Explanation of Intended Effects

Sydney Olympic Park Master Plan 2030 (Interim Metro Review)

October 2021

Published by NSW Department of Planning, Industry and Environment

Figure 4: Proposed SSP SEPP Height of Buildings Map

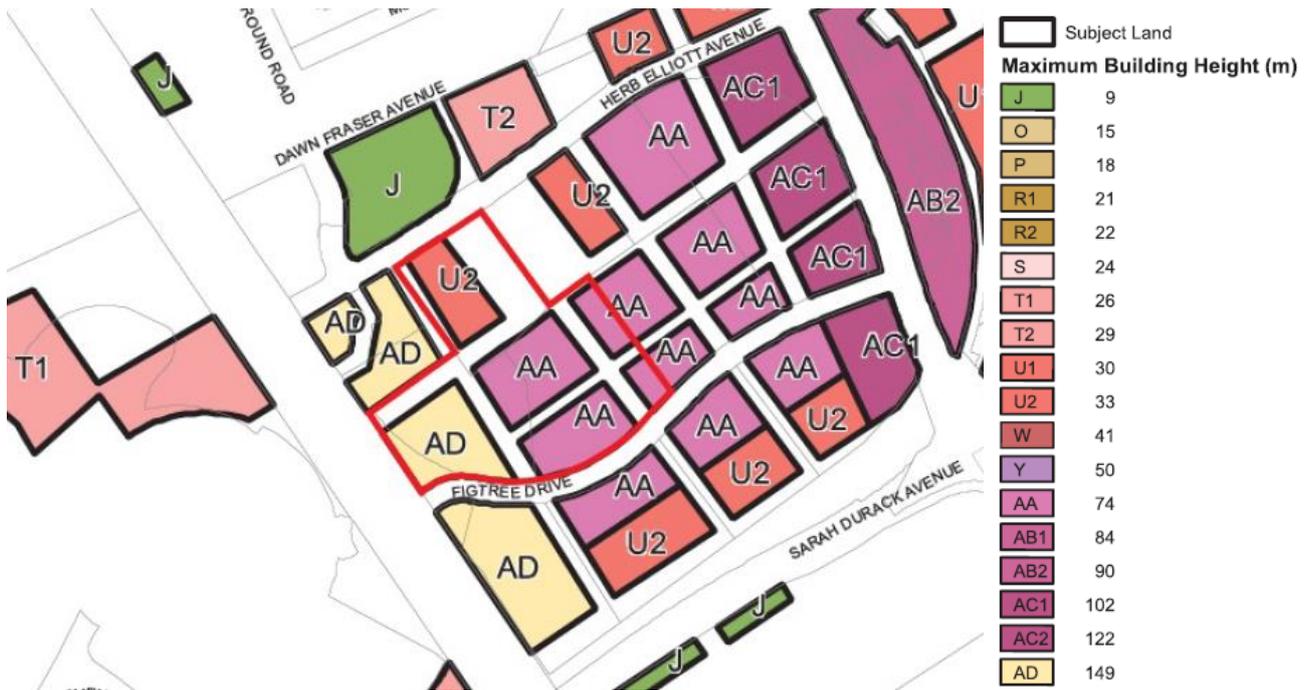
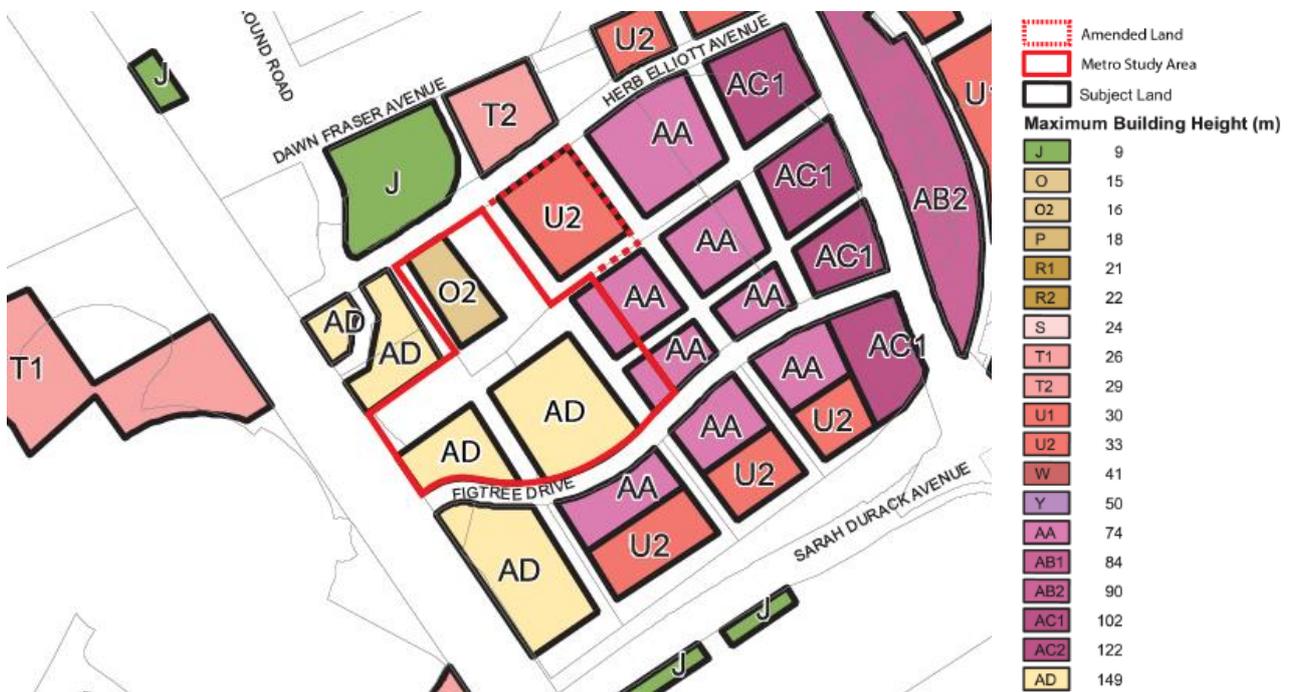
The existing SSP SEPP Height of Buildings Map (SEPP_SSP_SOP_HOB_001_20170919) is shown in **Figure 3**. It is proposed to make amendments to the site extents shown in the map to better align the height controls with the Metro site design and amend the maximum building heights that apply to the Metro sites.

The proposed amendments to the Height of Buildings Map are shown in **Figure 4** as follows:

- Site 40 – Decrease the maximum building height to 16m (currently 33m) to provide for the station box;
- Site 47 – Increase the maximum building height to 149m (currently 74m), reduce extent of height control in the north of the site;
- Site 48 – No change to maximum building height (149m), reduce extent of height control in the north of the site; and
- Site 41 (non-Metro site) – No change to maximum building height (33m), increase the extent of the maximum building height control to the west of the site.

The proposed variation to the height control seeks to provide a diverse and distinctive skyline for the Central Precinct and reinforce the Metro station location and the associated activity and amenity of the site. The proposed change to the extent of the height control for Site 48 is to facilitate the plaza, an open space area to the north of the site. This plaza space will have a dual purpose as a key civic space within the emerging town centre and an important marshalling space during major event egress. The 40m wide plaza space was identified as a key built form requirement within the proposed Master Plan 2030 (Interim Metro Review) to allow for a major event egress.

The amendment also seeks to alter the extent of the height control for Site 41 (which corresponds with the legal boundary of Lot 50 in DP747909) to achieve an improved urban form comprising a continuation of the urban street edge from Herb Elliot Avenue to Central Linear Park. The change to Site 41 is also due to the change in space allocation to the adjacent park. No change is proposed to the maximum building height for Site 41.

Figure 6: Proposed SSP SEPP Floor Space Ratio Map

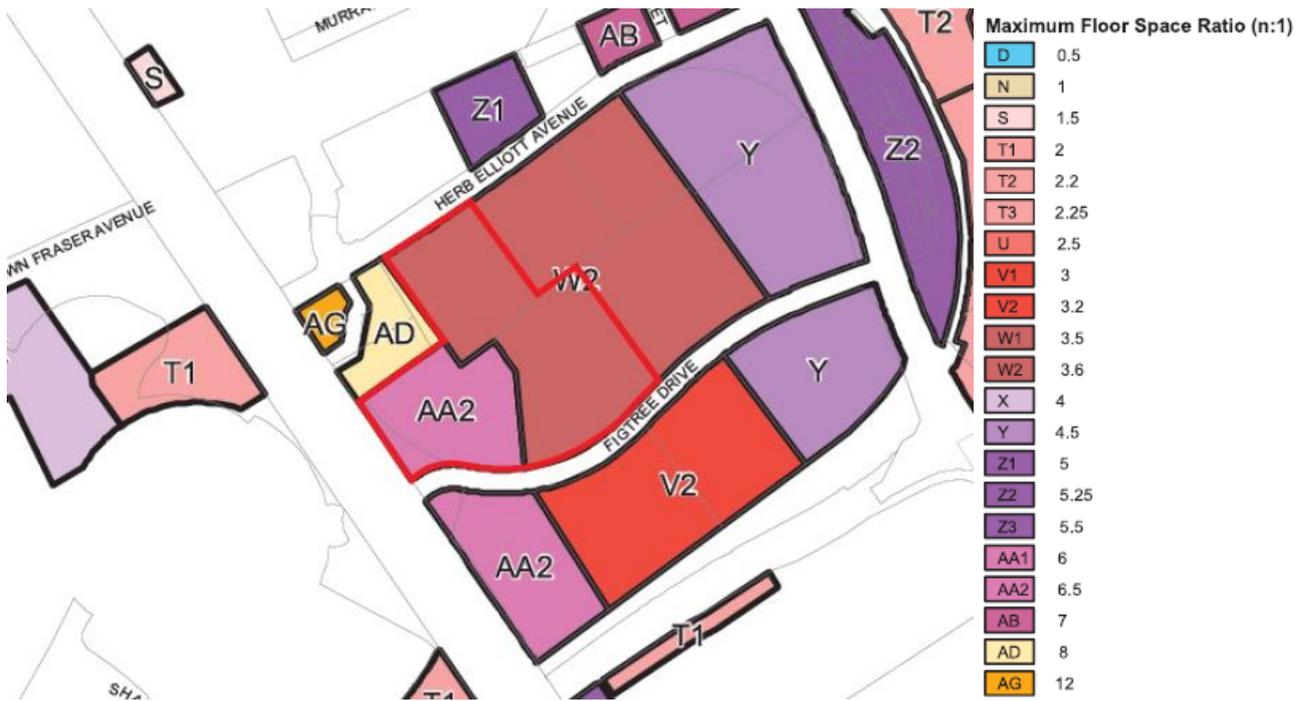
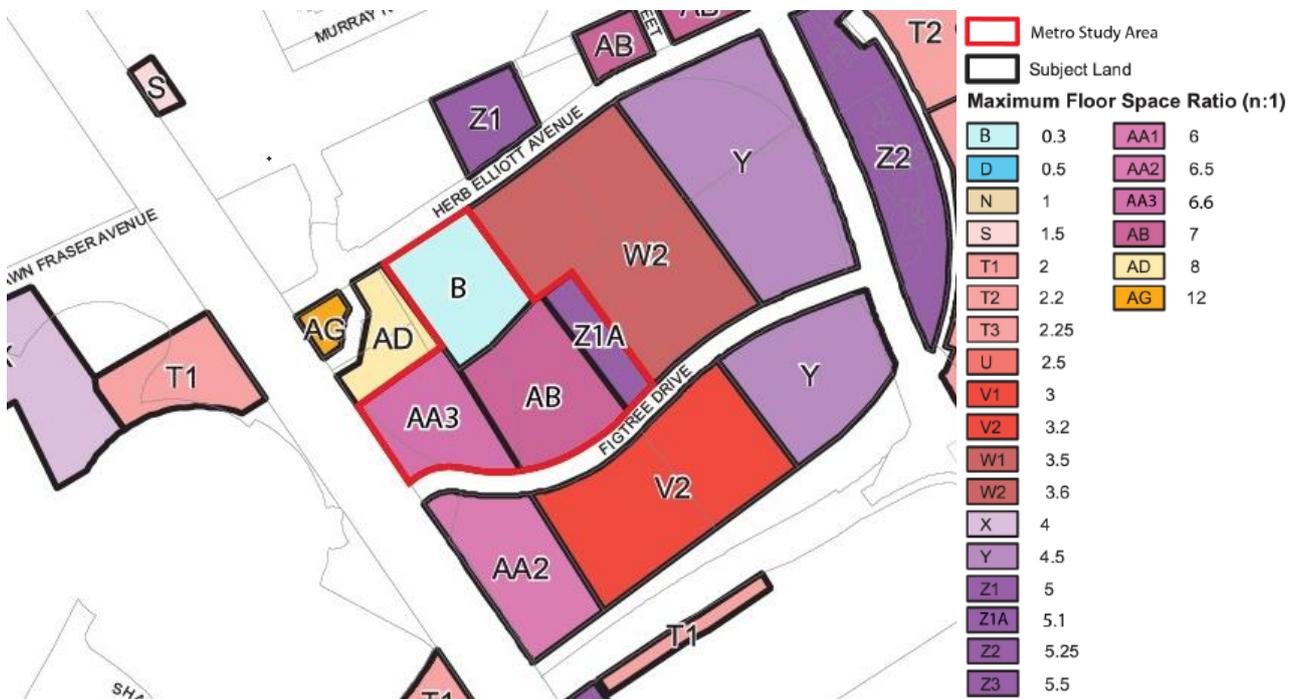
The existing SSP SEPP Floor Space Ratio Map (SEPP_SSP_SOP_FSR_001_20170607) is shown in **Figure 5**. It is proposed to amend the floor space ratios that apply to the Metro sites.

The proposed amendments to the Floor Space Ratio Map are shown in **Figure 6** as follows:

- Site 40 – Decrease the FSR to 0.3:1 (currently 3.6:1) to provide for the station box;
- Site 47 – Increase the FSR to part 7:1 and part 5.1:1 (currently 3.6:1); and
- Site 48 – Increase the FSR to 6.6:1 (currently 3.6:1).

The proposed amendments to the floor space ratio map are to accommodate the proposed changes to the maximum building heights on the Metro sites to facilitate development of the Metro station and retain the development capacity of the sites to provide additional jobs and housing choices. The amendments to the Floor Space Ratio (FSR) controls seek to complement the proposed building heights as tested in the Urban Design Study to determine an appropriate built form outcome for the sites.
